## **Urgent Field Safety Notice**

### **StealthStation™ S7 Cranial Software v3.1.4 Biopsy Depth Gauge Inaccuracy & Incorrect Distance to Target Text**

**Medtronic Reference: FA1324**

Figure 1 Distance to/past Target Text Inaccuracy seen in Navigate Task of Shunt Placement and Tumor Resection

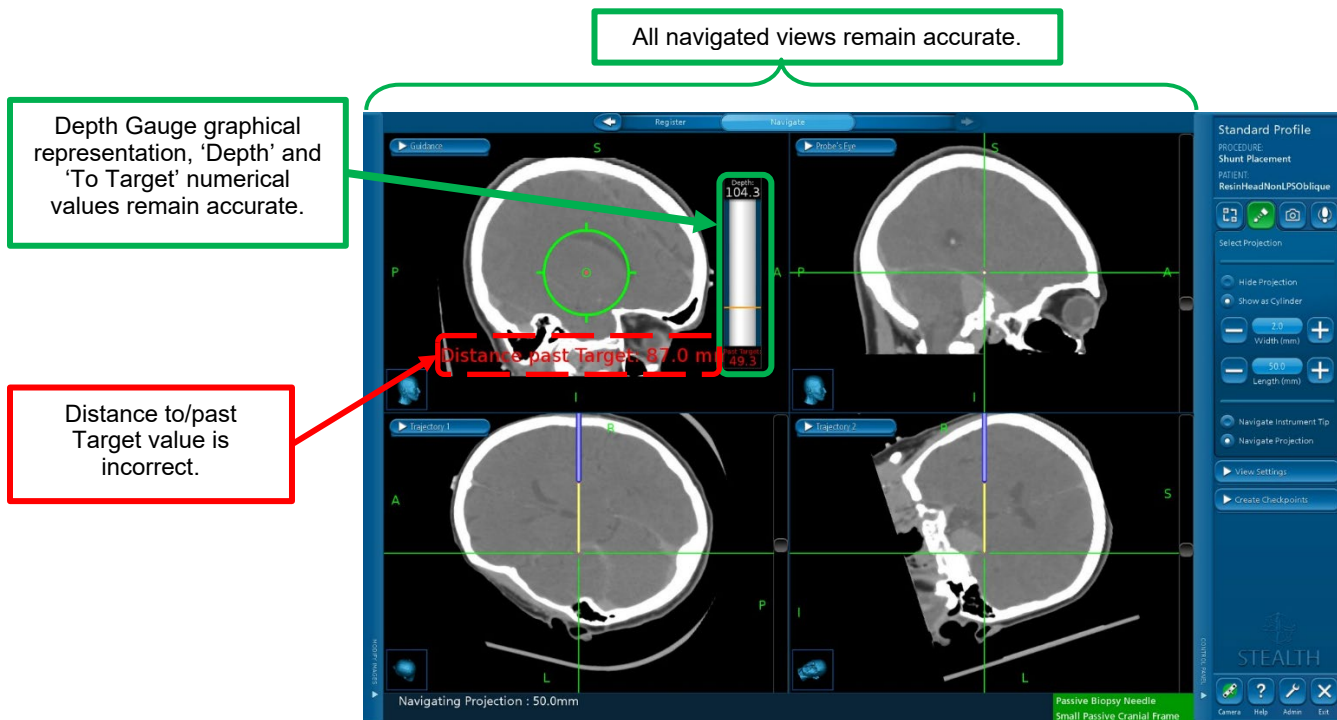
Medtronic identified an anomaly during our own internal testing that impacts Tumor Resection, Shunt Placement, (Refer to Figure 1) and Nexframe™ DBS procedures (Refer to Figure 2) with the Distance to/past Target text. This anomaly does not impact Cranial Biopsy procedures. When certain settings are used, the software can enter a state where the Distance to/past Target text is no longer synchronized with the rest of the navigational information on the screen and displays an inaccurate numerical value. All other information on the screen, including the Depth Gauge Graphic (Shunt Placement, Tumor Resection), remains accurate. The steps required to encounter this anomaly are as follows:

- Non-Axial exams (sagittal, coronal) and a small subset of non-standard Axial exams are used
- A surgical plan has been created and must be utilized.
- The Target Guidance option must be selected within the guidance view options.
- A tip projection must be utilized.
- The 'Navigate Projection' must be enabled.

Medtronic recommends that users do not utilize the Distance to/past Target value (outlined in Red in Figure 1) in Tumor Resection, Shunt Placement, or Nexframe™ DBS procedures due to the potential for the presence of this software anomaly. All other navigation information is unaffected and can be utilized to complete the desired procedure. Per the IFU: “Warning: Frequently confirm navigation accuracy and system responsiveness during live navigation. Use the navigation instrument to touch several bony anatomical landmarks and confirm that the locations identified on the images match the locations touched on the patient. If accuracy degrades, re-register the patient.” and “If system navigation seems inaccurate and steps to restore accuracy are unsuccessful, abort use of the system.”

Figure 3 Biopsy Depth Gauge Graphic Inaccuracy seen in Navigate Task

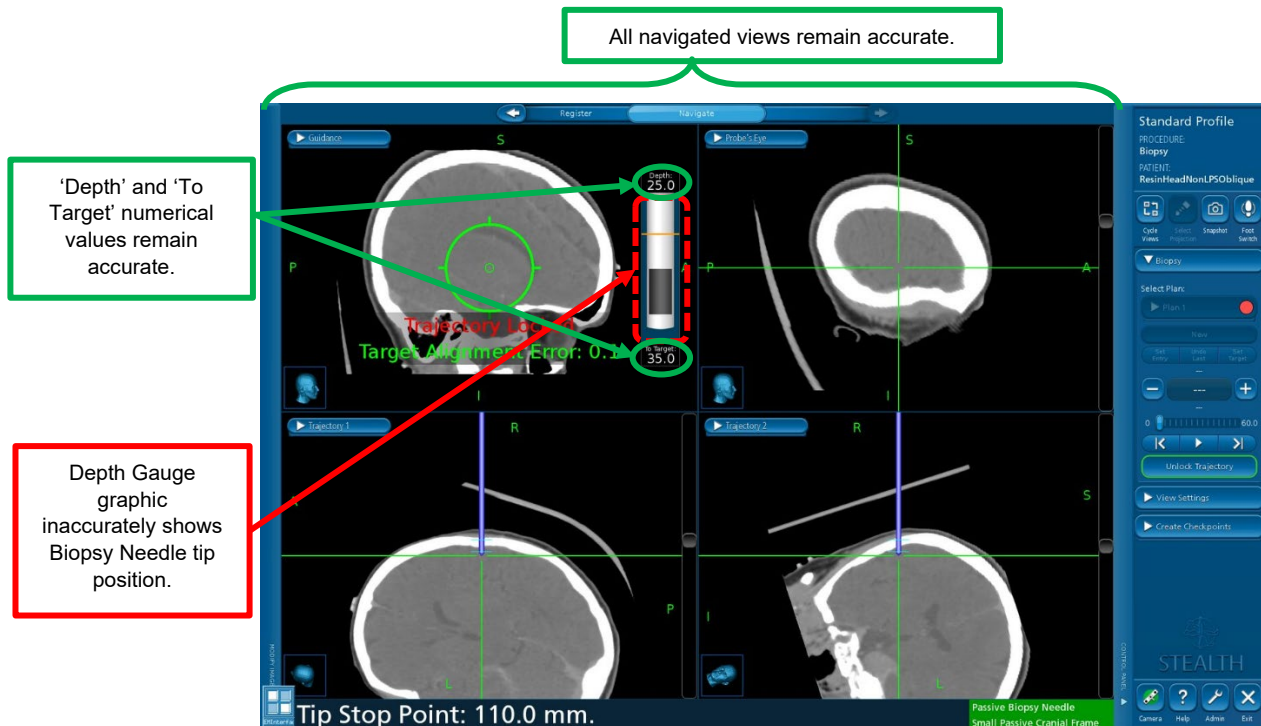
Medtronic has received three complaints reporting that during navigation in a Cranial Biopsy Procedure, the user encountered an anomaly with the Biopsy Depth Gauge graphical display in the software. Investigation of the complaints showed that when certain scan types are loaded and utilized, the software can enter a state where the Biopsy Depth Gauge graphic is no longer synchronized with the rest of the navigational information on the screen and displays an inaccurate position of the biopsy needle. This issue occurs with non-Axial exams (sagittal, coronal) and a small subset of non-standard Axial exams. All other information on the screen remains accurate.

Medtronic recommends that users do not utilize the Biopsy Depth Gauge Graphic in Biopsy procedures due to the potential for the presence of this software anomaly. All other navigation information is unaffected and can be utilized to complete the desired procedure.
